- 1 744 Victoria Road & 2A Eagle Street, Ryde - Demolition and construction of an up to 6 storey mixed use and residential development comprising 2 commercial tenancies on the ground floor, 32 dwellings (18x1 bedroom, 5x2 bedroom, 1x3 bedroom, 1 x 4 bedroom and 7x studio apartments) over 2 basement levels of car parking providing a total of 59 car spaces together with associated landscaping works - LDA2018/0117**

### City of Ryde Local Planning Panel Report

<b>DA Number</b>	LDA2018/0117
<b>Site Address &amp; Ward</b>	<ul style="list-style-type: none"> <li>• 744 Victoria Road and 2a Eagle Street, Ryde</li> <li>• 2-4 Eagle Street, Ryde</li> </ul> Central Ward
<b>Zoning</b>	B6 Enterprise Corridor under RLEP 2014
<b>Proposal</b>	Demolition and construction of an up to 6 storey mixed use and residential development comprising 2 commercial tenancies on the ground floor, 32 dwellings (18x1 bedroom, 5x2 bedroom, 1x3 bedroom, 1 x 4 bedroom and 7x studio apartments) over 2 basement levels of car parking providing a total of 59 car spaces together with associated landscaping works.
<b>Property Owner</b>	<b>744 Victoria Road:</b> CPD 888 Pty Ltd, AJ Harb Holdings Pty Ltd, Centurion 777 Pty L

**Figure 17:** North Elevation of amended plans #3 reviewed by UDRP

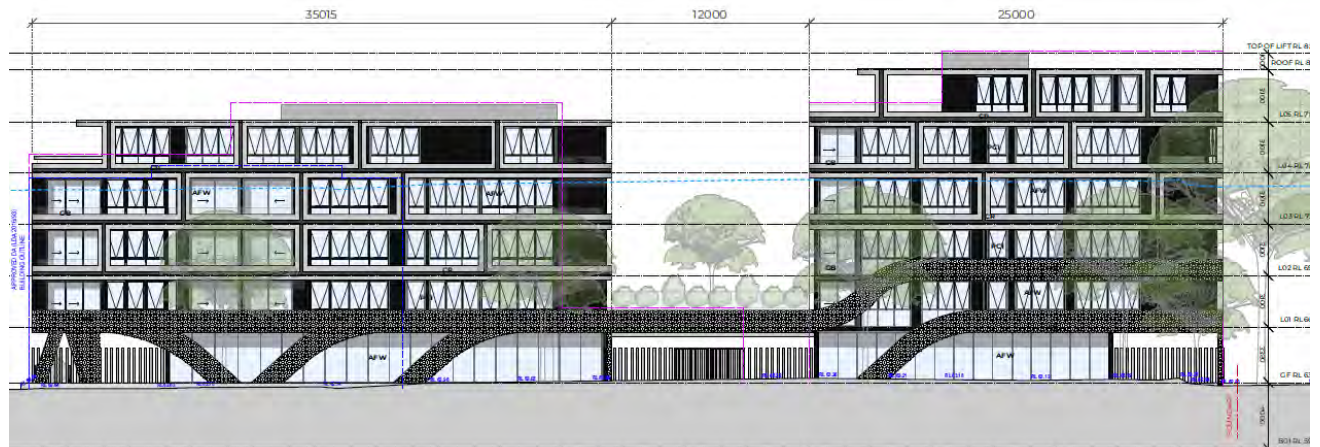
The proposal was most recently reviewed by the UDRP on 15 August 2019 after amended plans (#3) were received. The Panel had previously reviewed this application on a numerous occasions. The comments made by the Panel at the most recent meeting are included below.

SEPP 65 – Design Quality of Residential Flat Buildings	Comments
	<p>- Residential communal open space, which are not equitably distributed.</p> <p>- Interface with neighbouring property to rear. The slope of the site to the rear boundary means that a level of car park is above ground at the rear of the site with a largely inactive wall and limited landscape area.</p> <p><b>Assessing Officer comment:</b></p> <p>The amended plans (#5) received address the issues raised by the UDRP. Council's Urban Designer has confirmed they are satisfied that the amended plans align with Council's building envelope plan (key site diagram), with the exception of two small components on each tower. These form part of the lift overrun, and do not result in non-compliances with overshadowing or unacceptable building bulk.</p> <p>Additionally, the amended plans do not provide a 2m gap on the ground floor. This departure from the building envelope plan has been assessed by Council's Urban Designer as being acceptable in this instance, as the ground floor has clear glazing on the front doors. Therefore, a degree of openness is still provided in this section.</p> <p>Additionally, the lobbies have been reconfigured to ensure they have sufficient surveillance from the front of the building.</p>

SEPP 65 – Design Quality of Residential Flat Buildings	Comments
	<p><i>landscape architect should address the interface with apartment to achieve privacy.</i></p> <p><i>The Panel recommends that the building separation of 15m described in Council’s envelop be provided and suggests that floor space could be relocated to the ground floor as described above and potentially to Level 5 on the western building, where the small communal open space is currently proposed.</i></p> <p><b>Assessing Officer comment:</b></p> <p>The amended plans received address the issues raised by the UDRP. Council’s Urban Designer has confirmed they are satisfied that the amended plans address the issues previously raised by the UDRP.</p> <p>The ground floor lobbies have been reconfigures to increase passive surveillance and enhance amenity for residents/visitors. Seating has also been provided in these areas,</p> <p>Communal open space has now been provided on Level 01 and is accessible to the Western building, so that reliance on the communal open space in the eastern tower is no longer relied upon.</p>

**Figure 21:** North elevation showing extent of building exceeding 12.5m building height

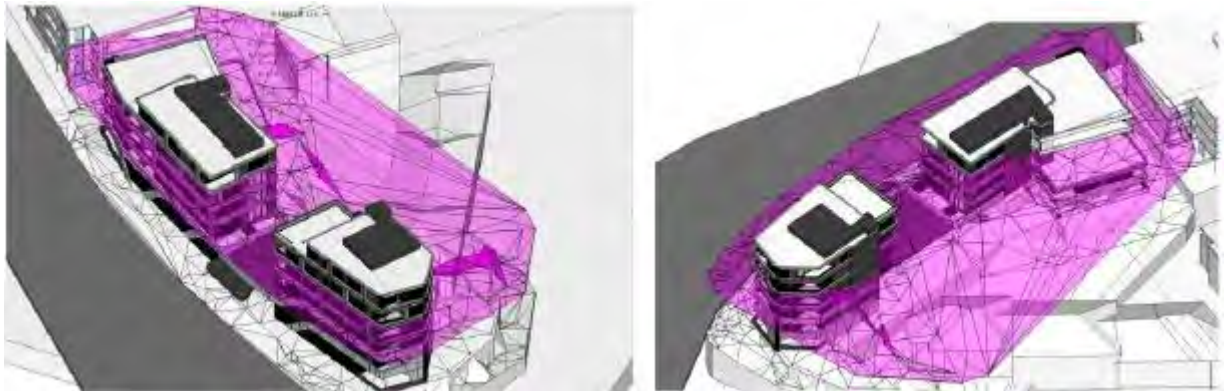
**Figures 21, 22 and 23** below illustrate the 12.5m height plane and the extent of non-compliance.

Accordingly, the applicant has submitted a written request seeking to justify the variation to the development standard contained in Clause 4.3. A Clause 4.6 statement accompanied the amended plans received in July 2020.

**Figure 24:** North Elevation comparison. Original plans (top) and amended (bottom)

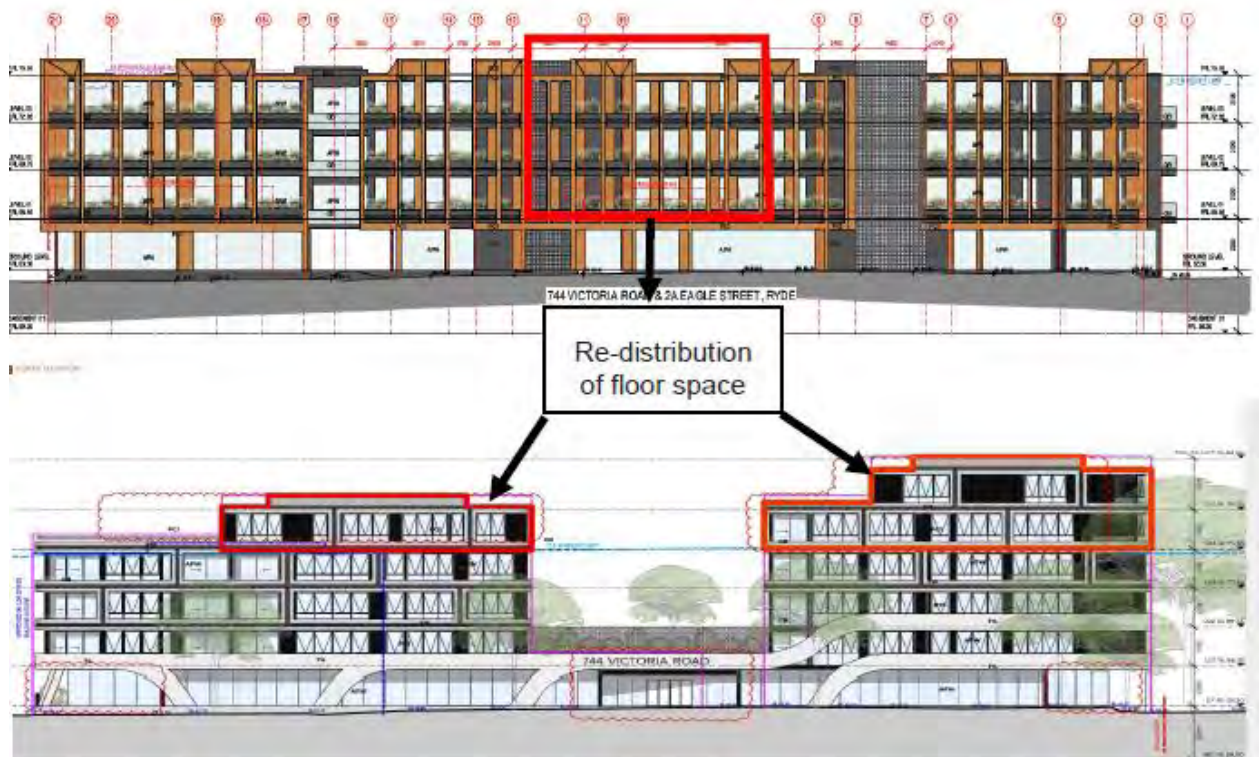
*“The element of the development which contravenes the “height of buildings” development standard is a result of the redistribution of floor space, not additional GFA or a breach of the FSR standard. As illustrated in **Figure 24**, the floor space originally located in the centre of the building, has been redistributed to the western and eastern elevations of the development, essentially creating two buildings on top of a common podium.*

Assessing Officer comment:

The constraints of the site, including the site's proximity to St Anne's Church, topography and configuration of the site, have led to the need for an alternative building envelope plan to be issued to the applicant by Council's Urban Strategy department. It was considered that the breach in building height, subject to adherence to the alternative building envelope plan, resulted in a better design outcome.

As such, it is agreed that there are sufficient environmental planning grounds to vary the building height development standard.

**Figure 29:** Built form strategy prepared by Council – Key Design Principles

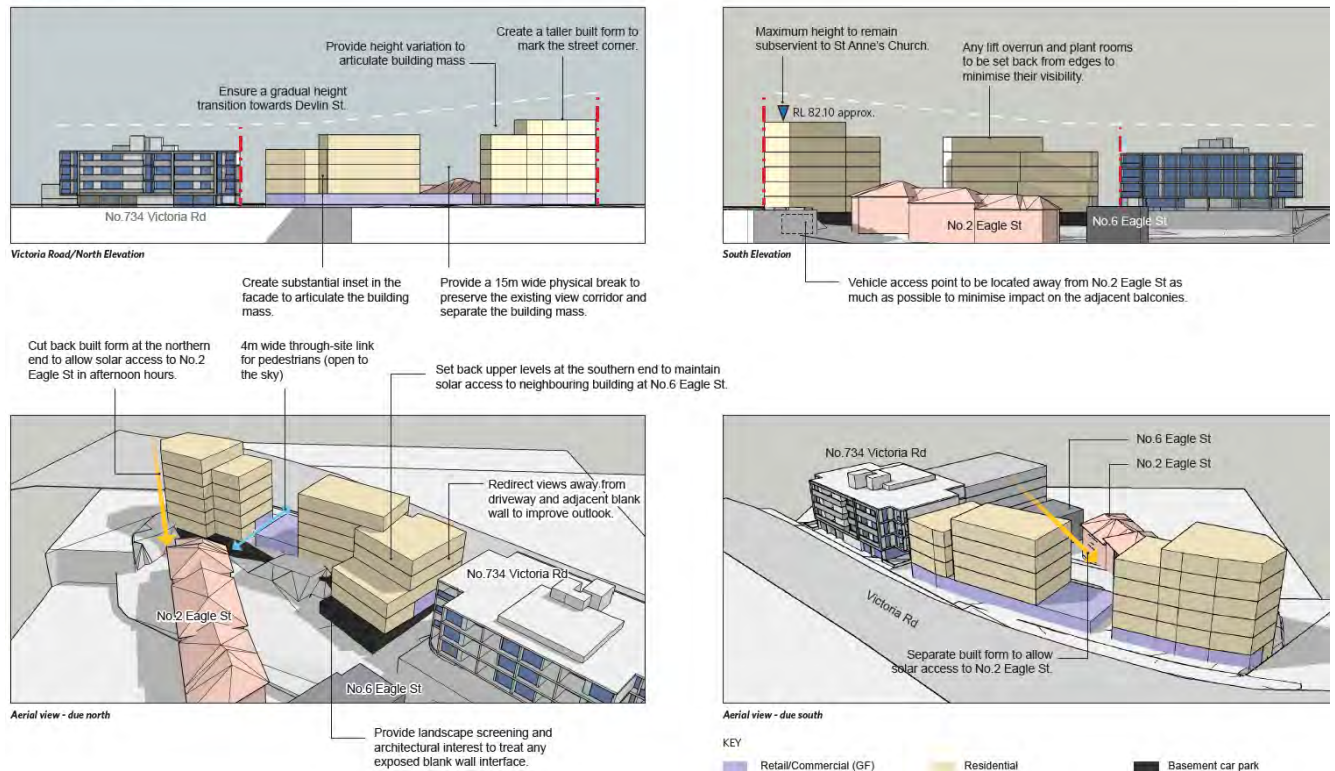
The alternative building envelope plan is shown in **Figures 27, 28** and **29** below.

The alternative controls improve the design outcome as follows:

**Figure 30:** Variation to building envelope plan shown in yellow

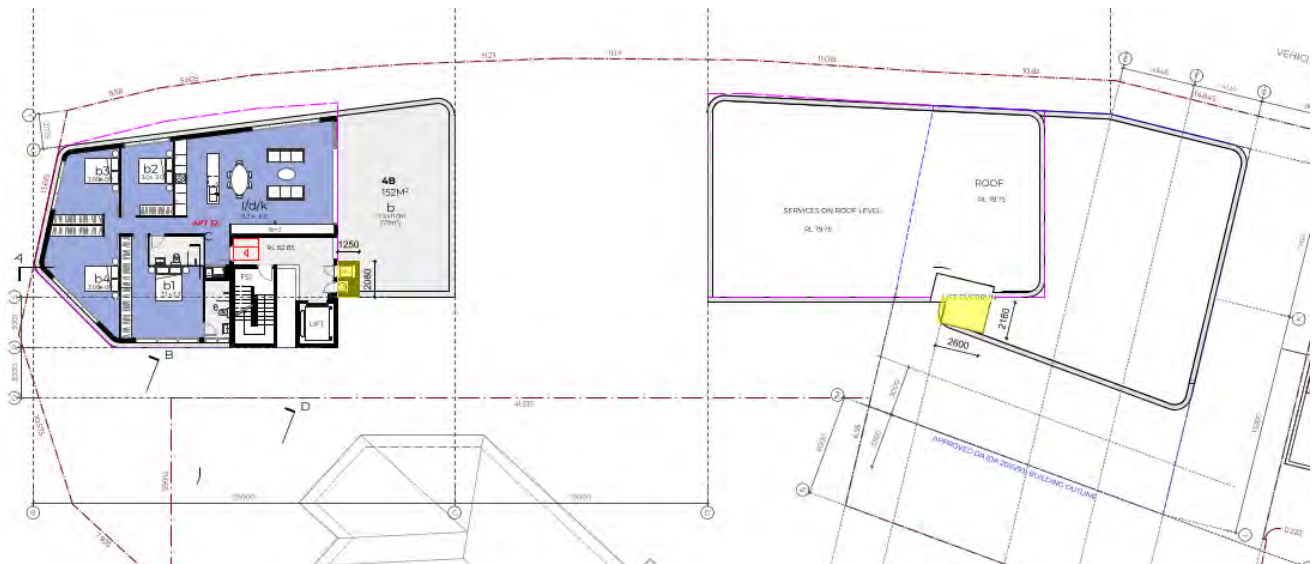
There are two variations on the upper levels of the proposed development that result from the location of the core functions in the basement which cannot be relocated. These areas are shown in yellow in **Figure 30** below.

The variation to Level 4 is for an area of 2.6m x 2.18m on the eastern tower for the lift well. This continues to Level 5 for the lift overrun. The lift cannot be relocated without having a major impact on the vehicular circulation space and fire stair in the basement levels.

**Figure 31:** Parking layout within basement level 2

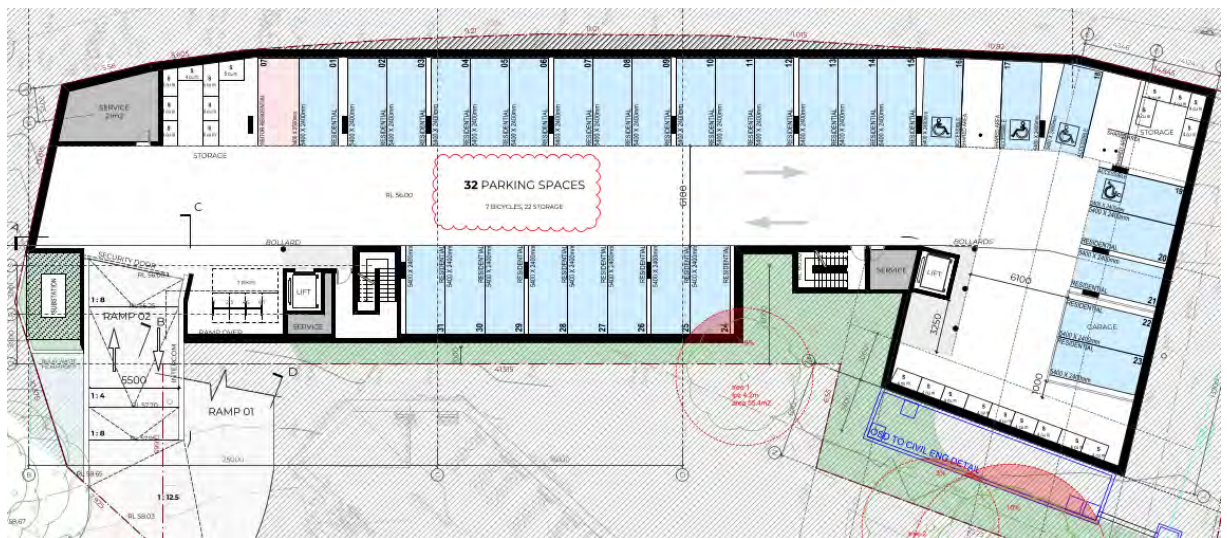
Figure 31 and 32 below shows the revised parking layout.

**Figure 35:** View from the sun diagram showing overshadowing to No. 2-4 and 6 Eagle Street

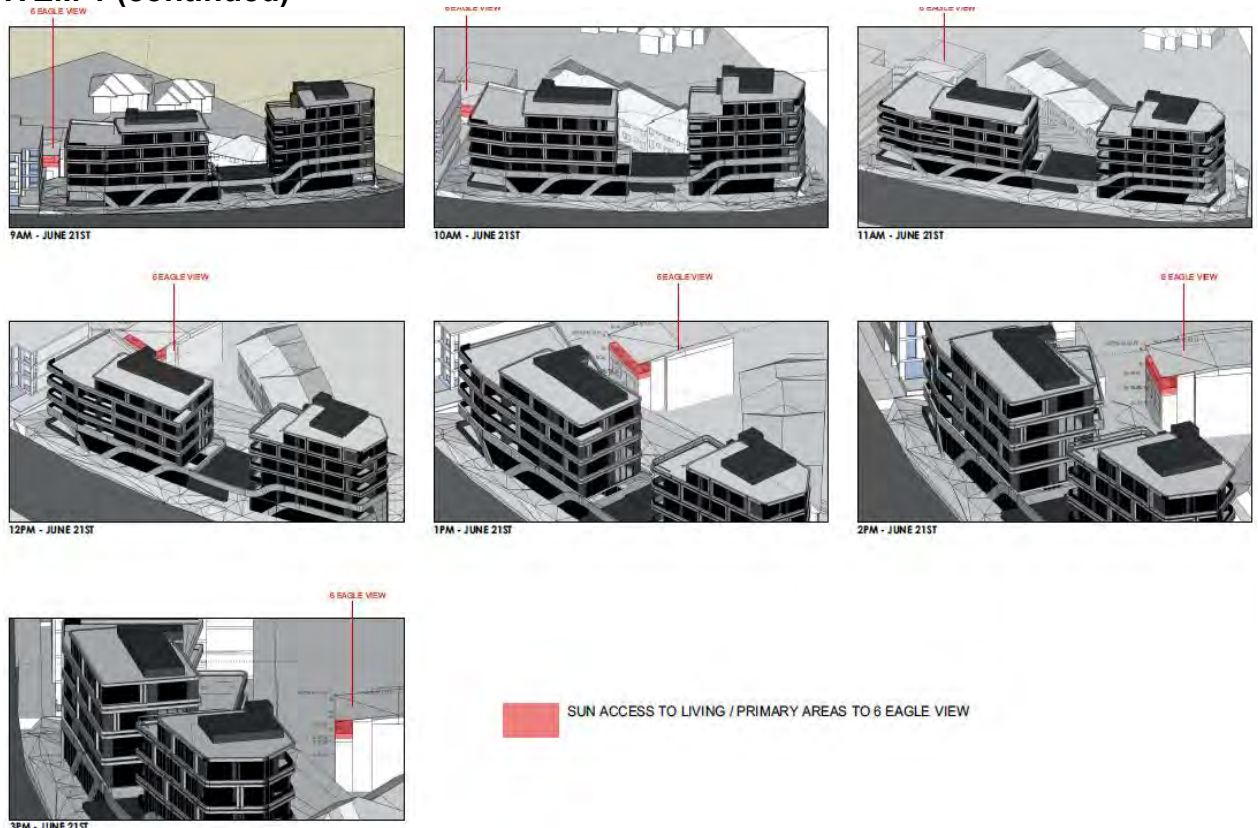
The amended plans received on 14 July 2020 reduced the overshadowing to the adjoining property, which is now compliant with the ADG controls and considered to provide a sufficient amount of solar access to adjoining properties.

A minimum of 2 hours sunlight is provided to the living room and balconies of the adjoining properties at No. 2-4 and No. 6 Eagle Street.

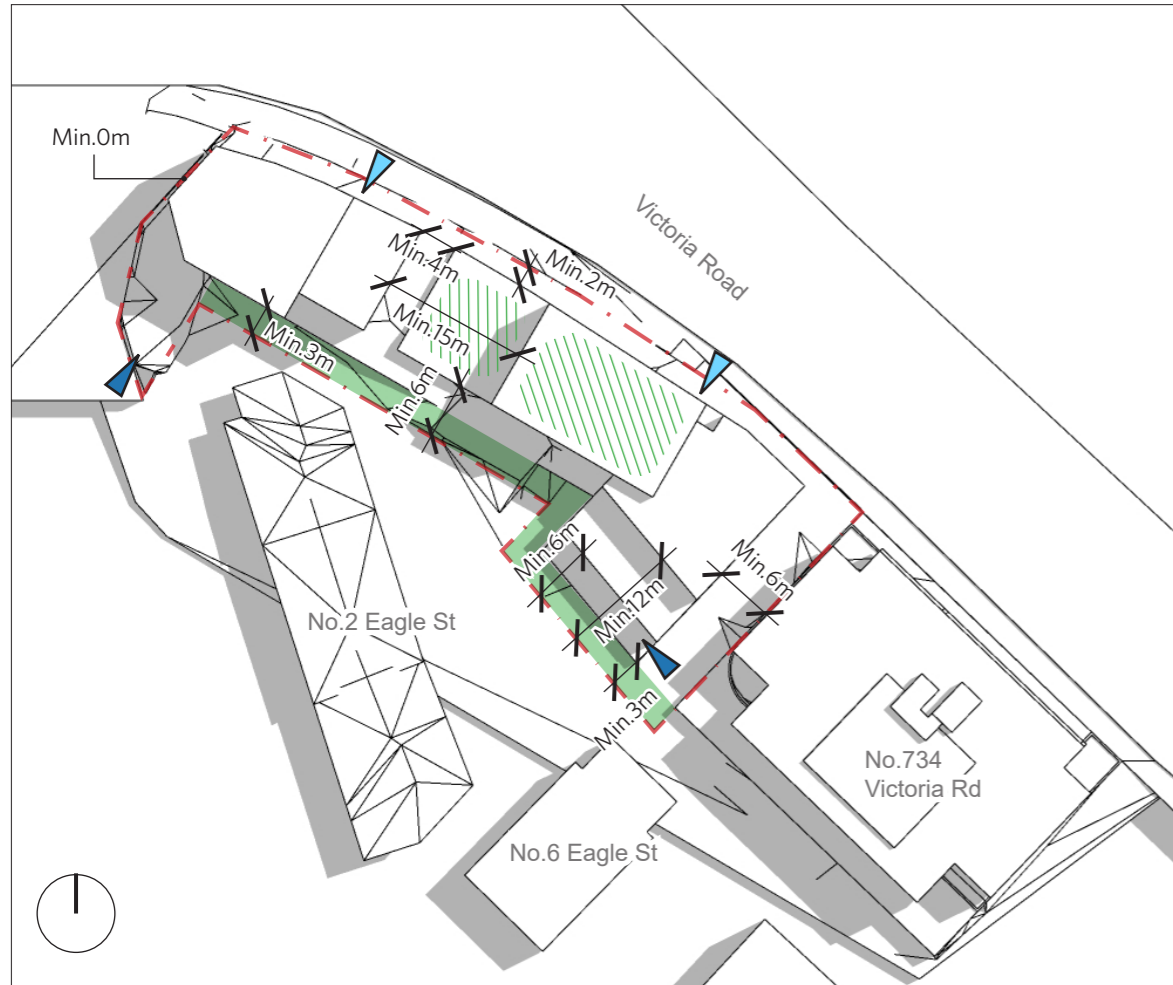
A view assessment should be provided to demonstrate how the proposal is able to preserve important public view elements from St Anne's Church site. The view assessment is to be undertaken from St Anne's Cemetery facing in a south and southwest position. Detailed and certified photo montages are required to be prepared and submitted, providing a graphical representation of the proposed built form when viewed from St Anne's church, St Anne's Cemetery and Church Street.
